I wanted to give a formal pat on the back to yourself and the others involved with the standards revision. The following are some comments and suggestions for improving the standards even further. Please call if there are any questions.

Thank you for the request to contribute suggestions for changes to the revision of the Handbook for Public Playground Safety. Following are my suggestions. I am returning a copy of the revised addition, with the item suggestion highlighted, as an appendix. My suggestions will be referenced by page number (p. #), item number (item #. #. #) and section title.

I have completed my review of the draft revision to the CPSC Handbook for Public Playground Safety.

Thank you for sending a draft of a revised CPSC Handbook for Public Playground Safety for my review. My compliments for your continuing outstanding work on children's safety. My review follows:

Figure 10(c)
Access to Raised Portions of Playstructures — Stairways

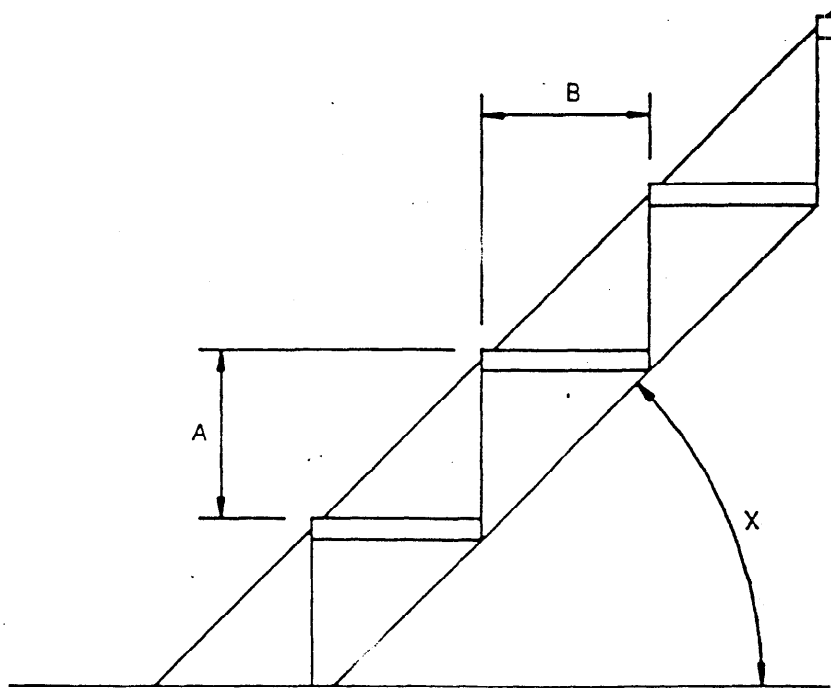
My other comment is regarding the slope of Stairways. This current draft is indicating that an acceptable slope for a stairway is 35° or less. It seems that this recommendation is inconsistent with the rest of the current "world" standards and/or recommendations. The current ASTM F1487 Standard recommends a stairway to be 50° or less, the current Canadian Standard CSA-Z614-M90 recommends a stairway to be 30°-50° (see attached), the British Standard BS-5696: Part 2: 1986 recommends that stairways have a slope between 15°-45° and 45°-55° (see attached). The current CFA Model Law recommends that a stairway have no slope greater than 50° (see attached). The current Malaysian Standard MS 966: Part 2 recommends stairways to be 15° and 45° (see attached). The current draft of the European Committee for Standardization CEN draft prEN 1176-1 recommends that stairways have a slope between 15° and 60° (see attached).

It is my intent to persuade CPSC to take another look at the stairway slope recommendation and to possibly harmonize the May 1997 draft with the current ASTM F1487 Standard.
